DfT Reference: TWA/24/APP/03
Document Ref: CD26-01-APP-W9-3
The Cambourne to Cambridge Order

APPENDICES TO PROOF OF EVIDENCE
of
Jack Southon
of WSP

CAMBOURNE TO CAMBRIDGE (BIN BROOK HYDRAULIC MODEL REVIEW)

Figure 1: Downstream boundary not snapped to code layer

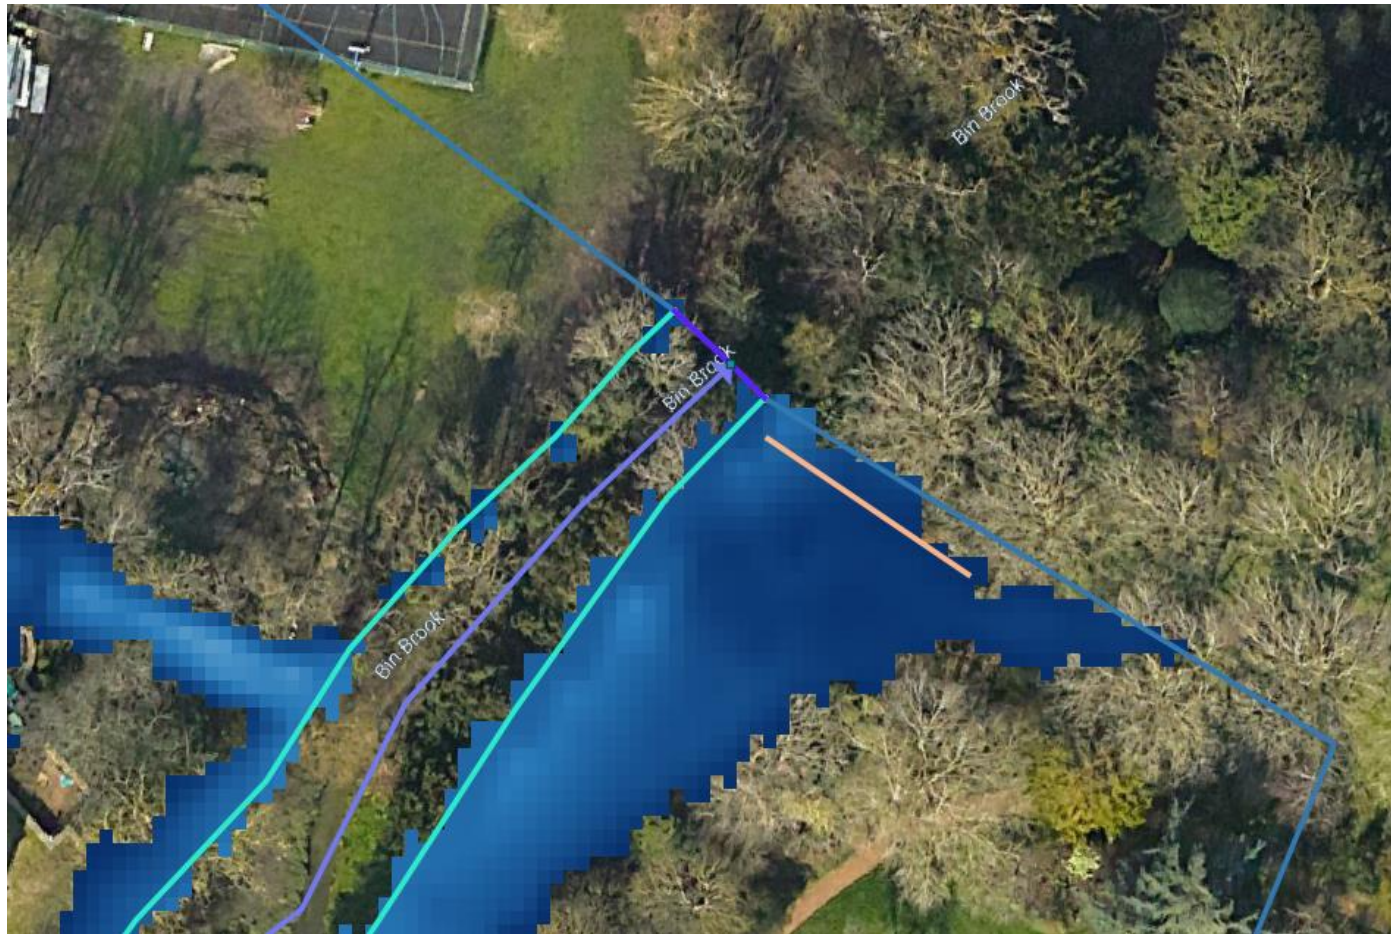
9.2	Is the model boundary suitably large? i.e. the flood extent should not reach the boundary.	Red	There is glass walling at the downstream extent of the model as the downstream boundary is not snapped to the 2d_code layer, and also does not extend far enough east, see Figure 1 in the 'Figures' tab. There is also glass walling in all three events at the upstream boundary, see Figure 5 in 'Figures' tab. No other glass walling.	Extend the downstream boundary eastwards to cover the full extent of the flooding. Justify the presence of glass walling at the upstream extent of the model.	The downstream boundary has been updated to snap to the code layer. Extended upstream extent of the model to prevent glass walling.	Red	There is still some glass walling - please see Figure 16.

Figure 3: HX link gaps at watercourses and structures need closing

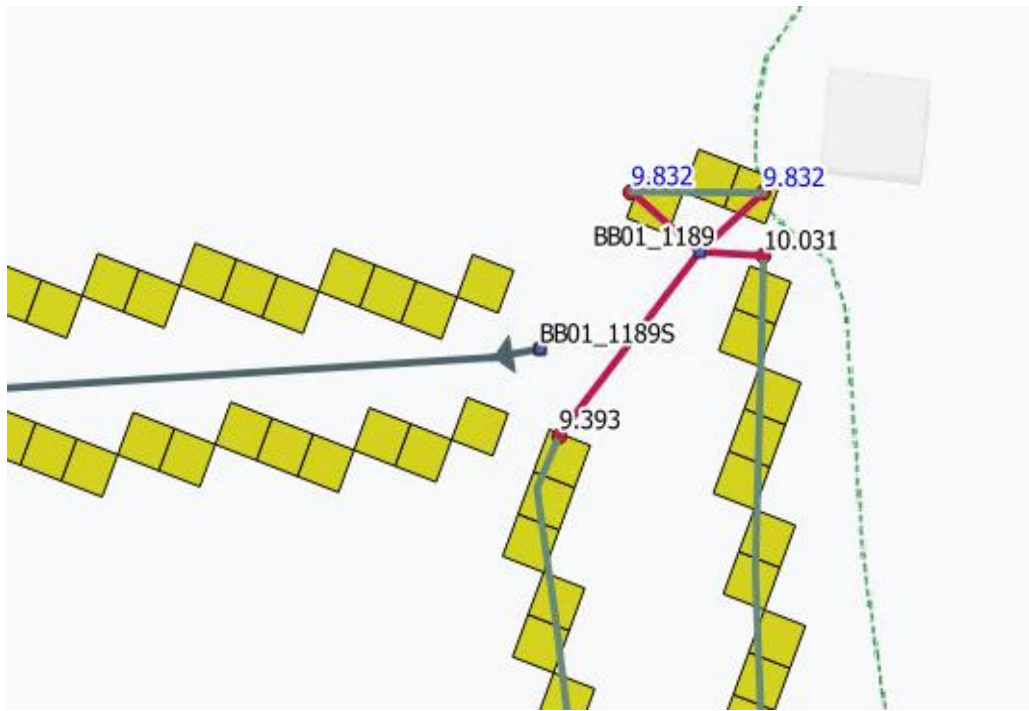
12.1	How have the 1D/2D models been coupled, is it appropriate?	Red	The 1D and 2D domains have been linked using HX and CN lines. Connections have mostly been digitised appropriately. The upstream of the model should be snapped to the code boundary (see Figure 2 in the 'Figure' tab). The HX lines at the structures throughout the model and the link to the ditch need to be reviewed, many should be closed so a single HX line is applied (see Figure 3 in the 'Figures' tab as an example).	Please amend throughout the model.	Gaps in the 1D and 2D domains have been closed.	OK	The code boundary is snapped with the upstream boundary. The gaps have been closed

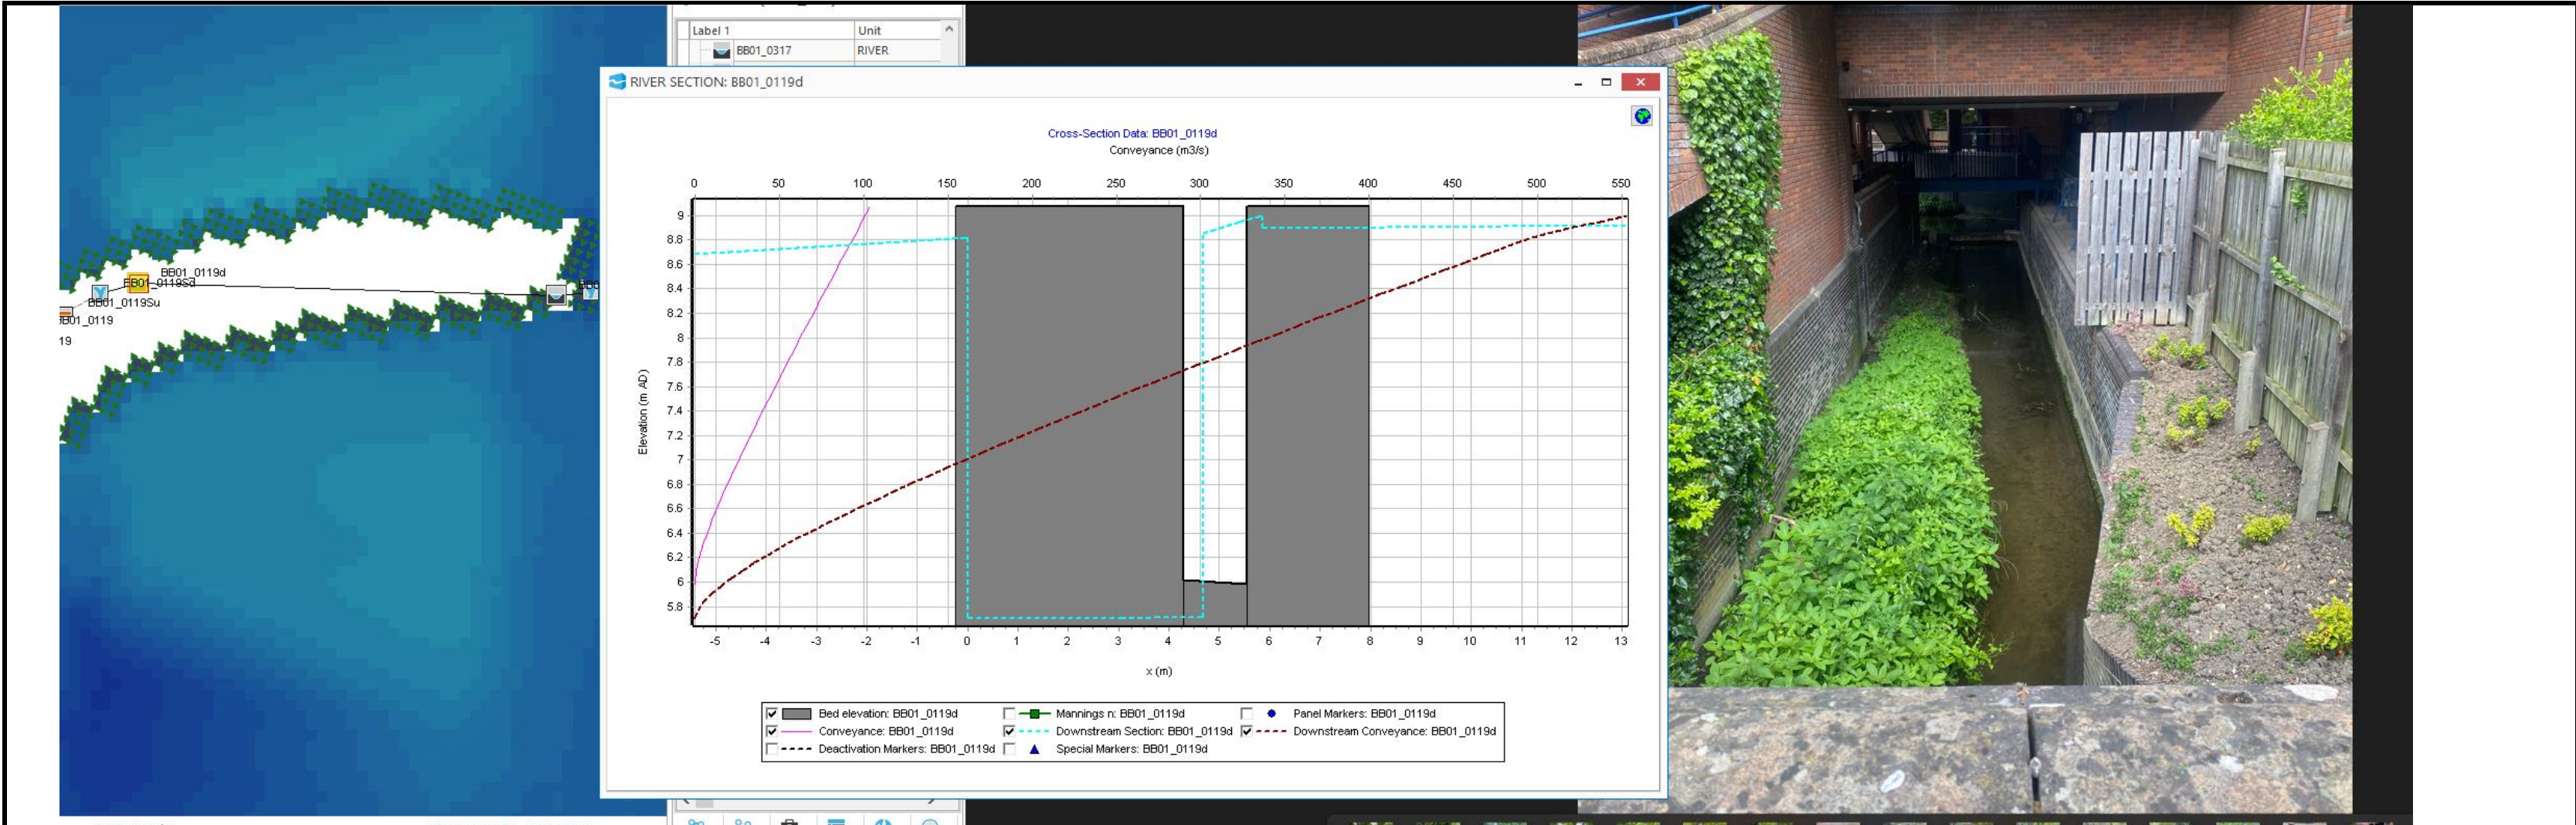
Figure 9: Section BB01_0119d is located downstream of the weir BB01_0119. The distance to next is 70m to the bridge. The channel cross section is 1.7m wide upstream and 4.7m downstream - this is modelling a tapering channel, the survey photo suggests the channel widens immediately downstream of the weir - the modelled channel reach appears to be too narrow as interpolates from one section to the next.

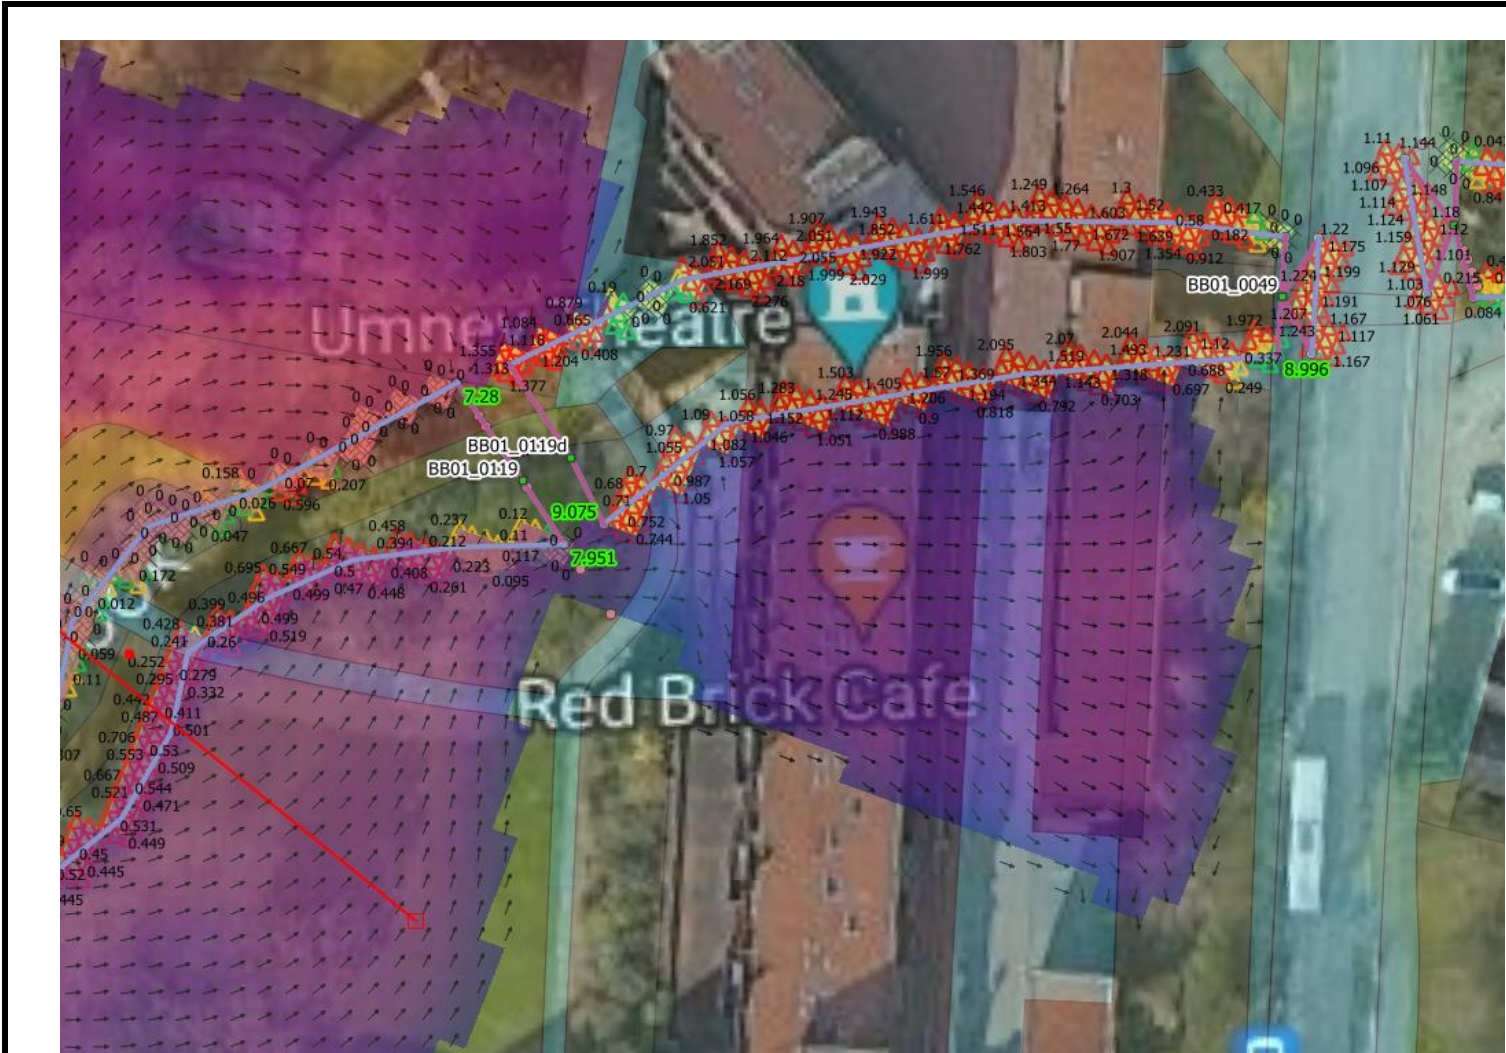
Figure 11: Split in the 2D link location for the weir looks slightly too far upstream. Flow appears to be by-passing the weir but the survey photos indicate ground levels behind may be higher. Modelling buildings a manning's 'n' is standard however in this instance further consideration needs to be given on the levels and flow mechanisms being modelled under / through the building. Are these correct, can water flow through the building and back into channel?
